ADDENDUM NO. 2

WASHINGTON STATE PARKS AND RECREATION COMMISSION KLUCKITAT STATE PARK TRAIL SWALE CANYON TRAIL IMPROVEMENTS EW-C6526

DATE: February 15, 2024

ALT A1
 V-FRAME GATE
 DETAILS

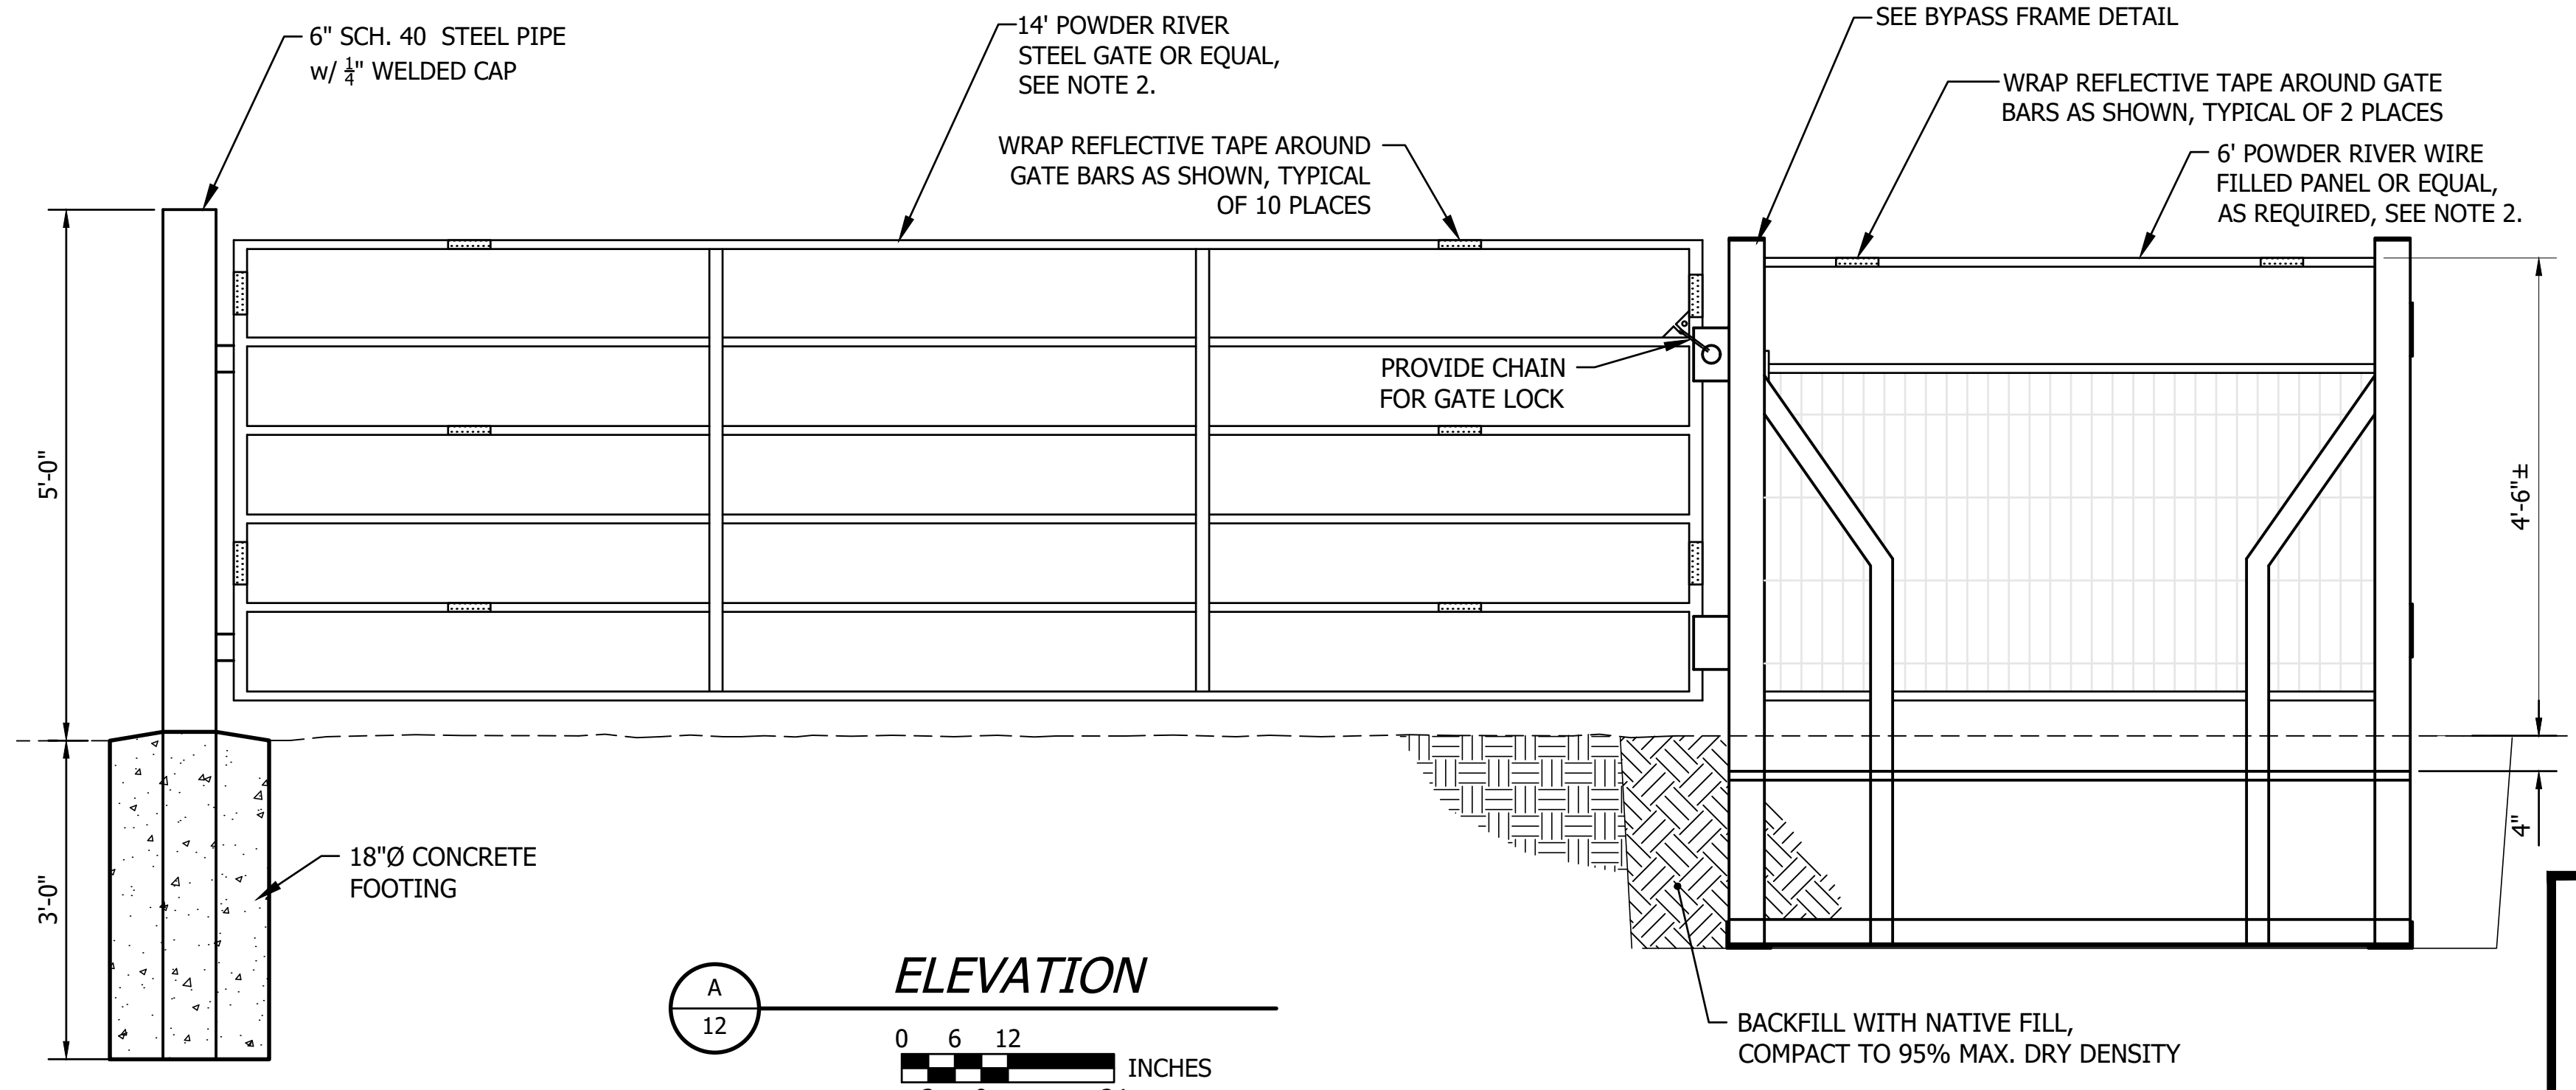
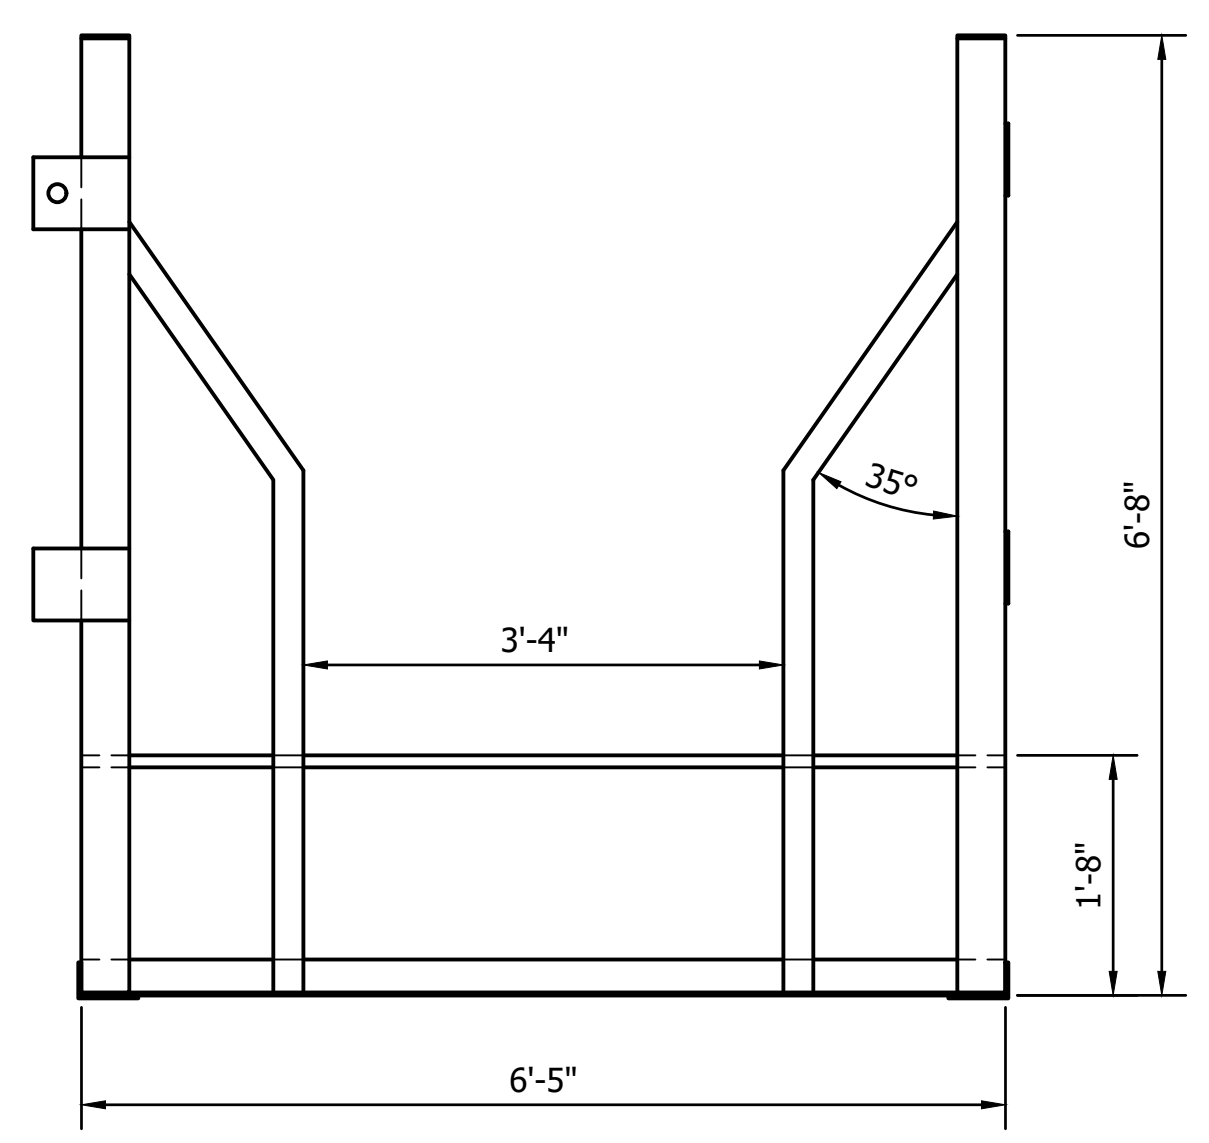
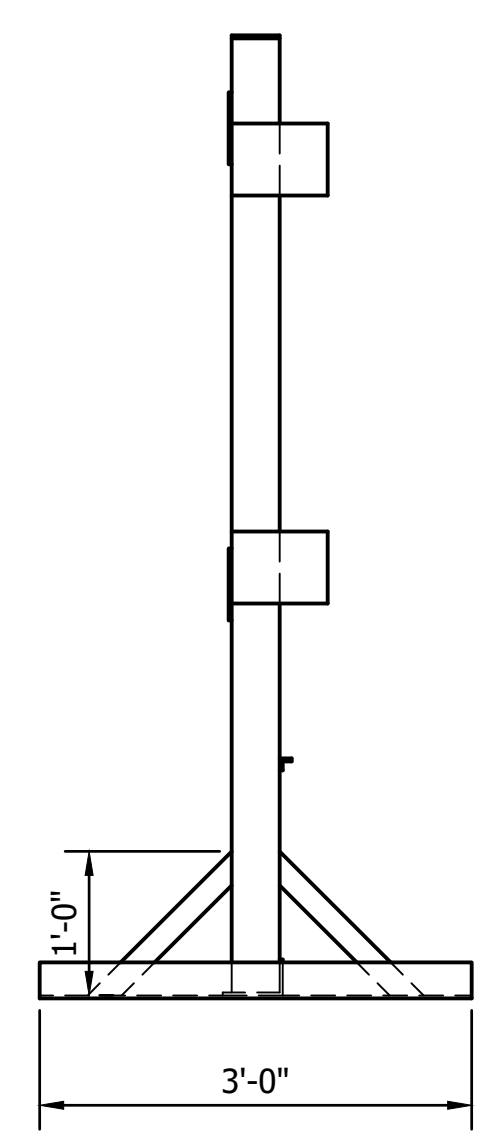
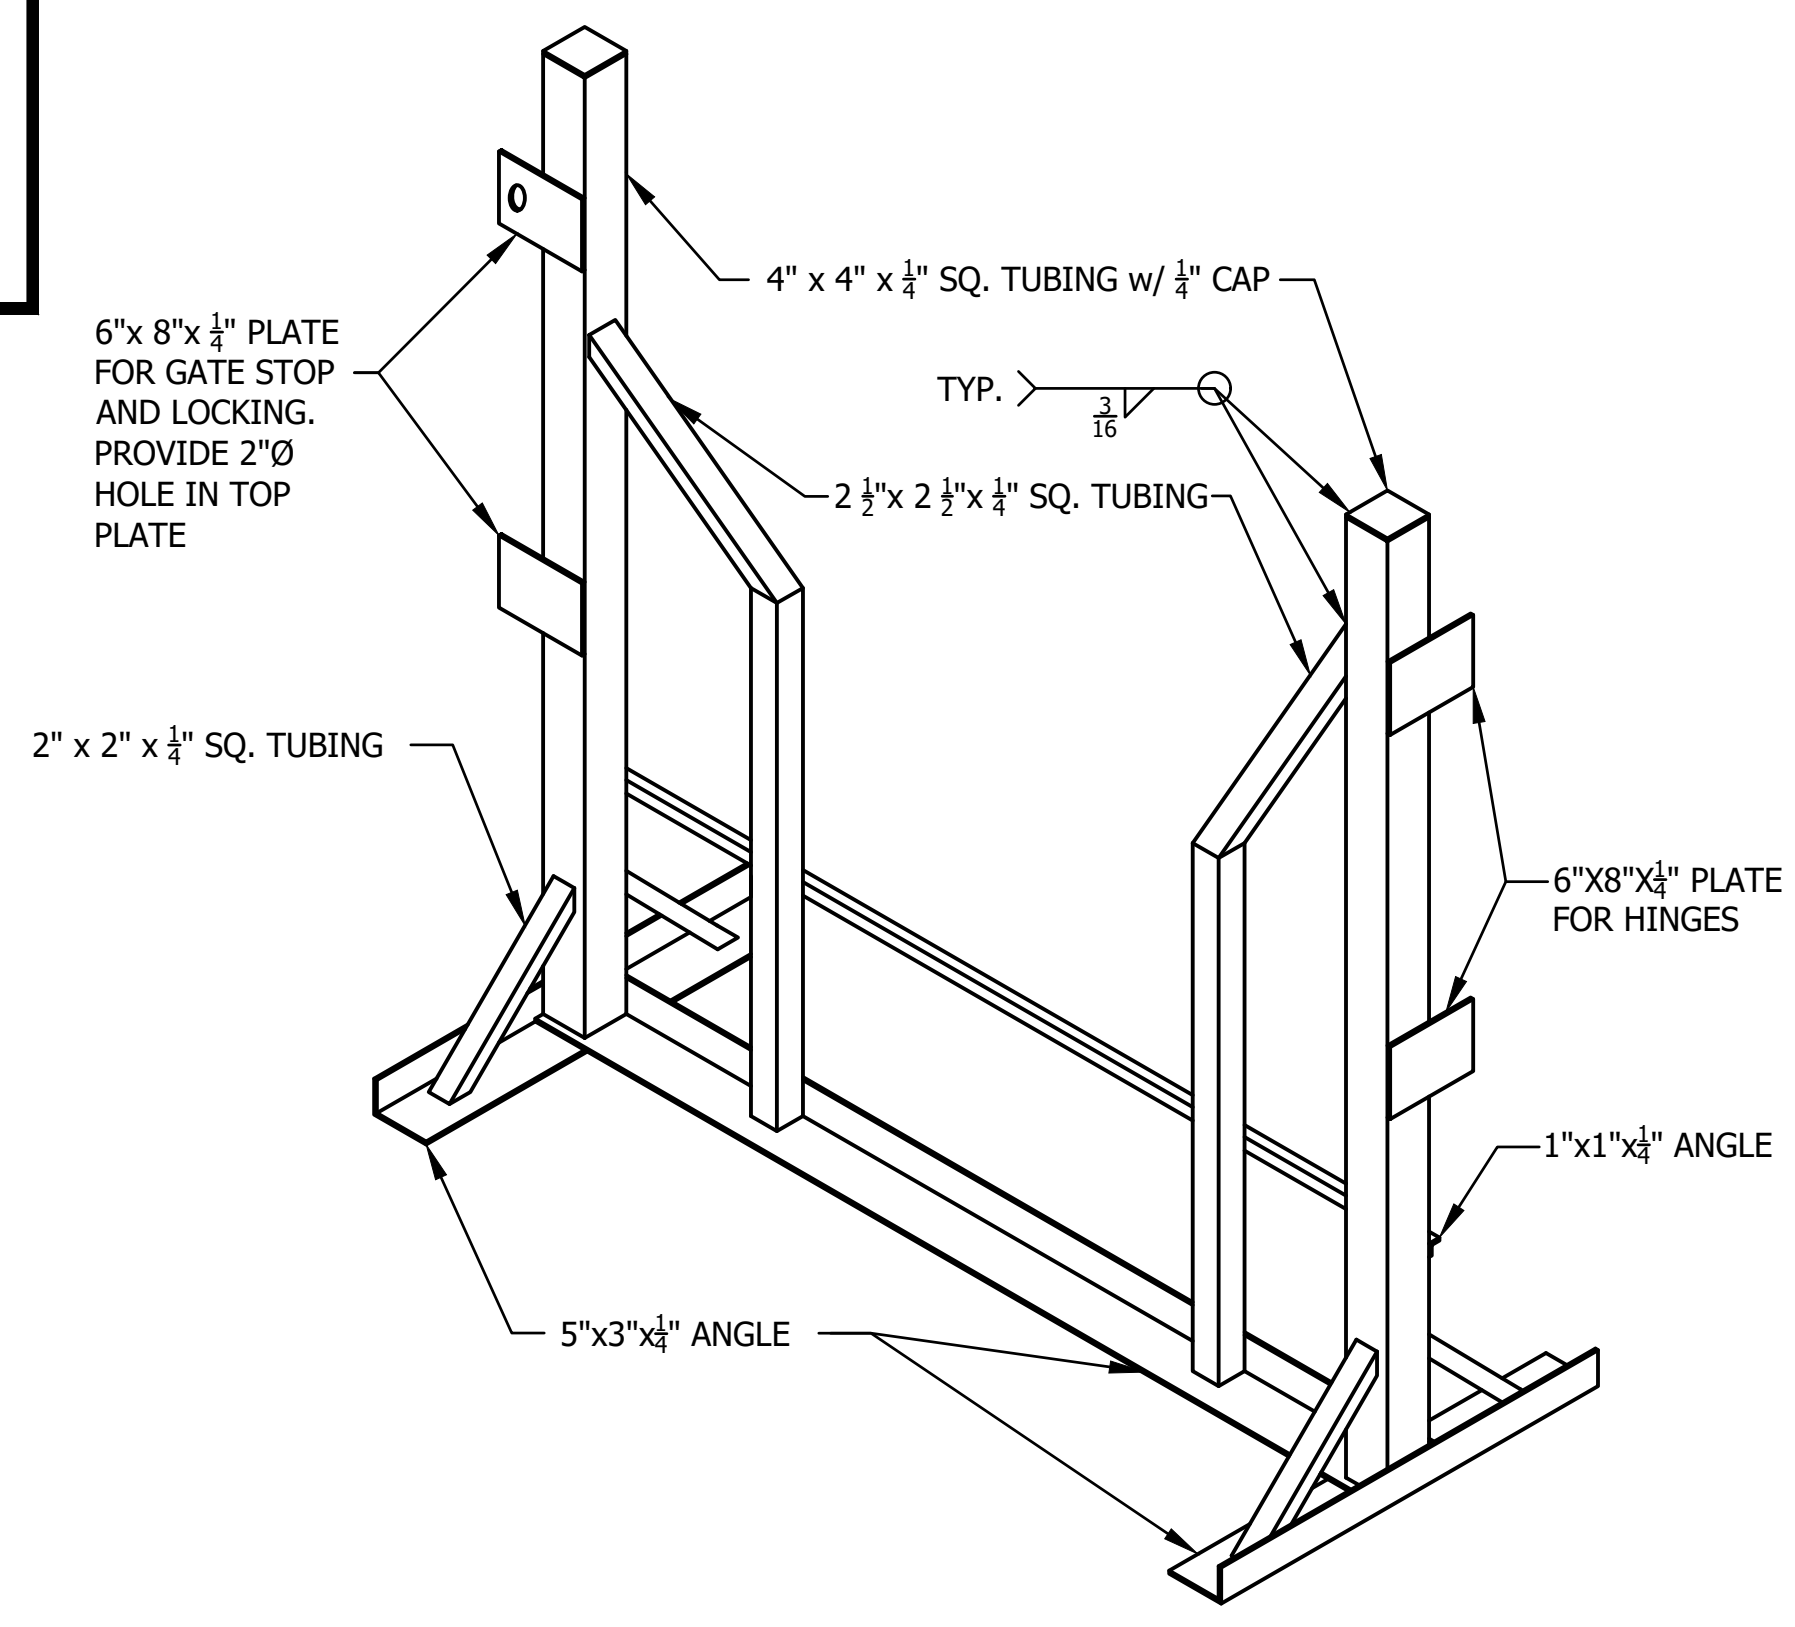
- A. The prefabricated gates and panels shown on sheet 12 of the project drawings (ALT A1 - V-FRAME GATE DETAILS) called out as a 14' Powder River steel gate (shall be equivalent to this product <https://powderriver.com/product/1600-tube-gates/>) and the 6' Powder River wire filled panel (shall be equivalent to this product <https://powderriver.com/product/wire-filled-gates/>). These gates and/or panels should all be powder coated using the manufacturer's standard color that most closely resembles Bittersweet Chocolate by Benjamin Moore (<https://www.benjaminmoore.com/en-us/paint-colors/color/2114-10/bittersweet-chocolate>).
- B. Self-Closing Hinge for the V-Frame wire mesh gate shall be Weld-On spring hinges from Hardware Source part #980014. The Gate Latch for the V-Frame wire mesh gate shall be the SPEECO one way gate latch part #S16100500.
